Planning & Zoning Board Staff Report for July 9, 2019 Meeting

SPR#19-08 REQUEST OF SHANE AND MICHELLE MCGUINNESS FOR: APPROVAL TO CONSTRUCT A ONE-STORY, 1,209 SQUARE FOOT ADDITION AND NEW POOL/DECK TO THE SINGLE-FAMILY HOME LOCATED AT 2040 VENETIAN WAY ON LAKE MAITLAND, ZONED R-1AAA.

Planning & Zoning Board Staff Report for July 9, 2019 Meeting

CU#19-08 REQUEST OF THE MAYFLOWER RETIREMENT COMMUNITY TO: AMEND THEIR PRELIMINARY CONDITIONAL USE APPROVAL AND PROVIDE FOR FINAL CONDITIONAL USE APPROVAL FOR EXPANSIONS OF THE MAYFLOWER RETIREMENT COMMUNITY AT 1620 MAYFLOWER COURT AND 2141 OAKHURST AVENUE.

SITE PLAN

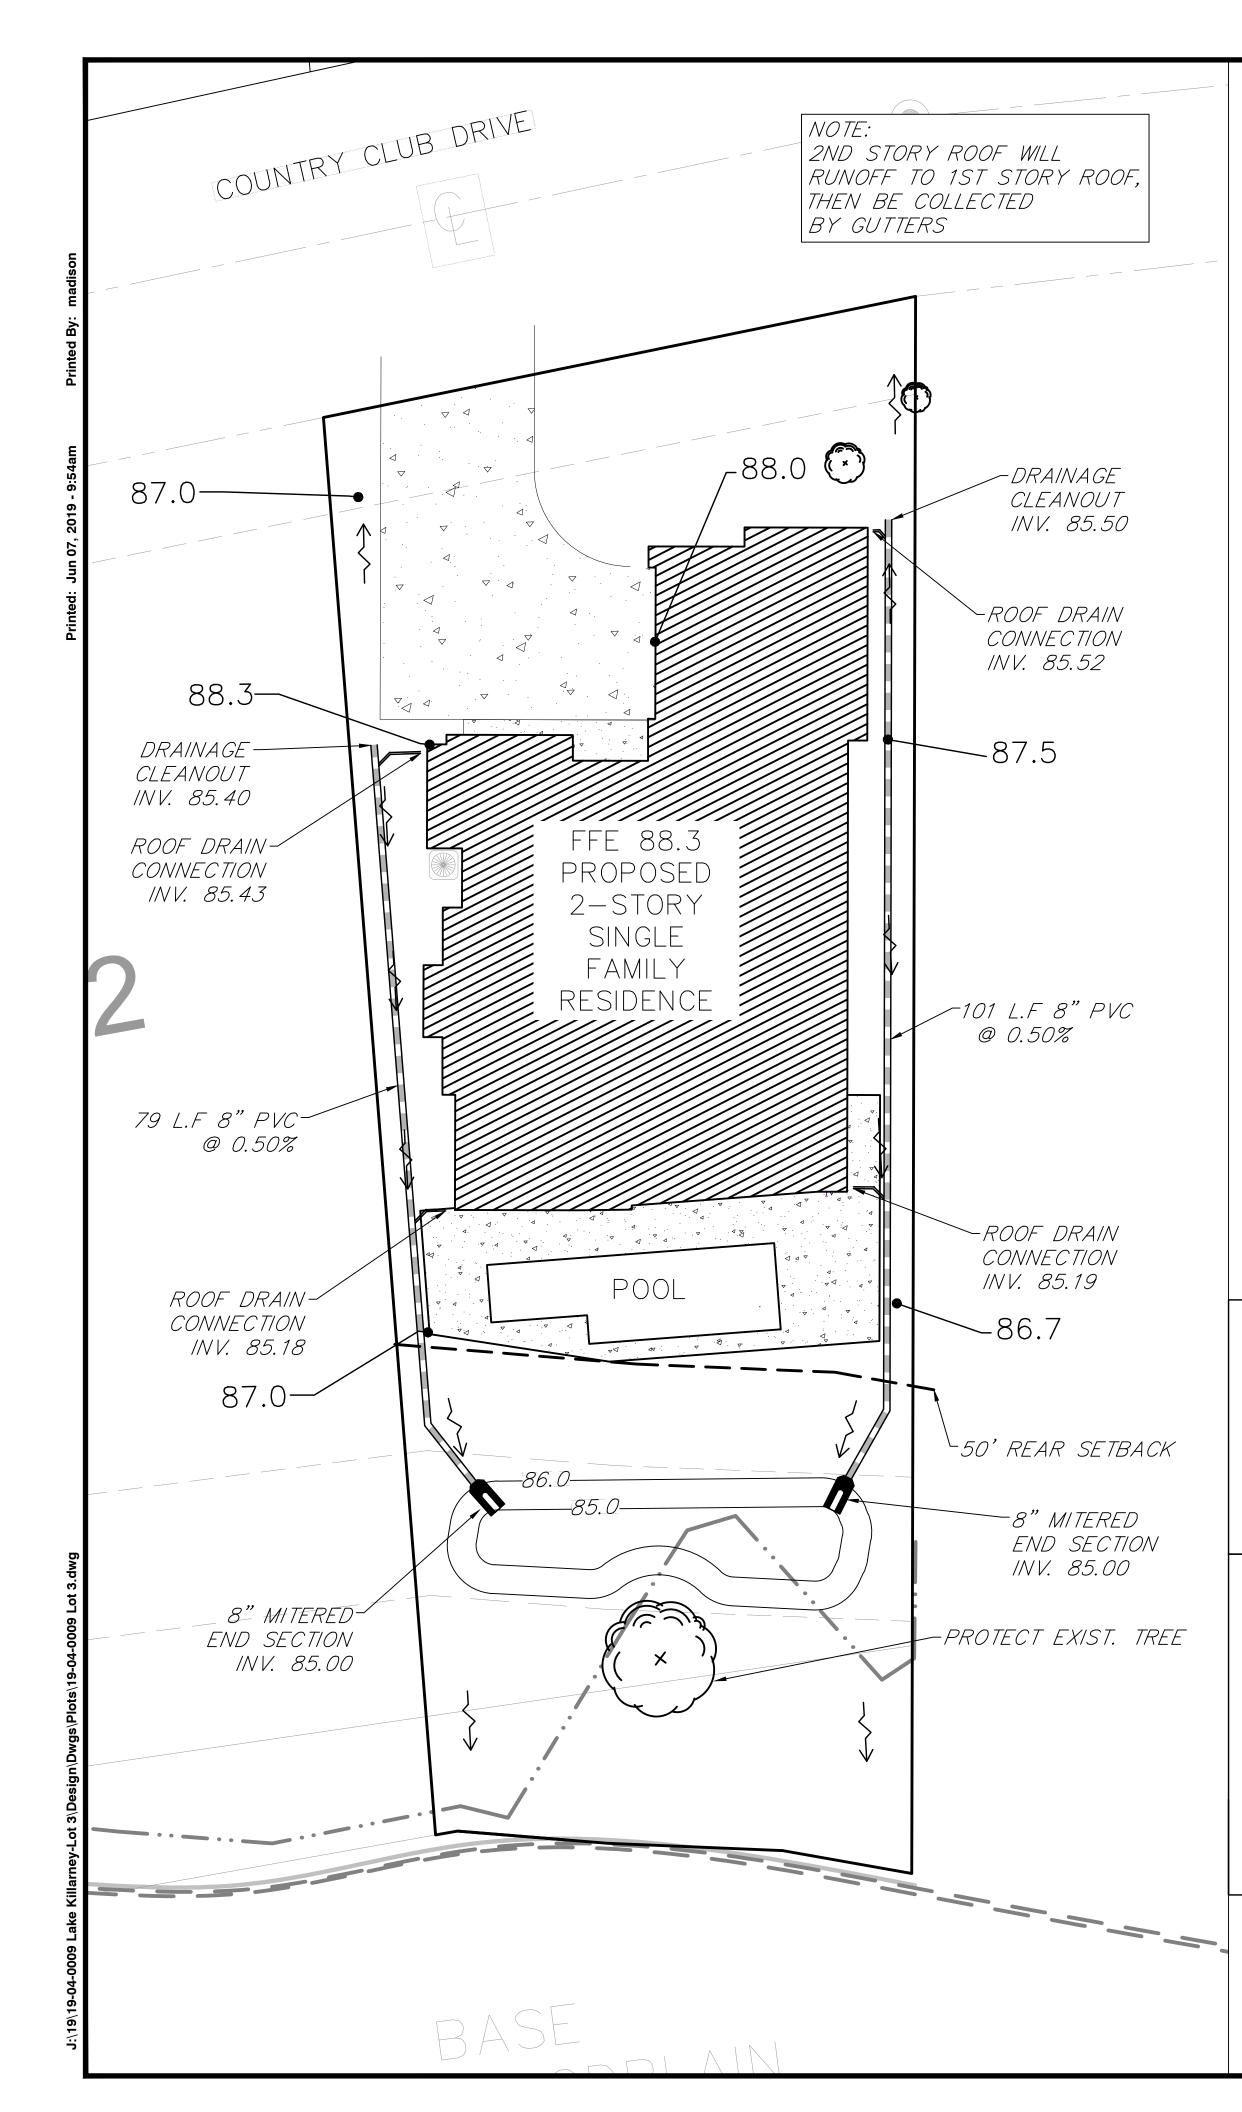
(REV: 6/5/19 CITY OF WINTER PARK COMMENTS: 1. VERIFY POOL IS NOT BEYOND 50' SETBACK 2. DRAINAGE PLAN BY OTHERS 3. INDICATE EXISTING TOPOGRAPHY 4. INDICATE NHWL ELEVATION TO VERIFY SETBACK MEASUREMENTS 5. INDICATE EXISTING GRADES ON ELEVATIONS (SEE ELEVATION SHEETS) 6. CITY TO VERIFY 5' GARAGE SETBACK 7. INDICATE EXISTING TREES
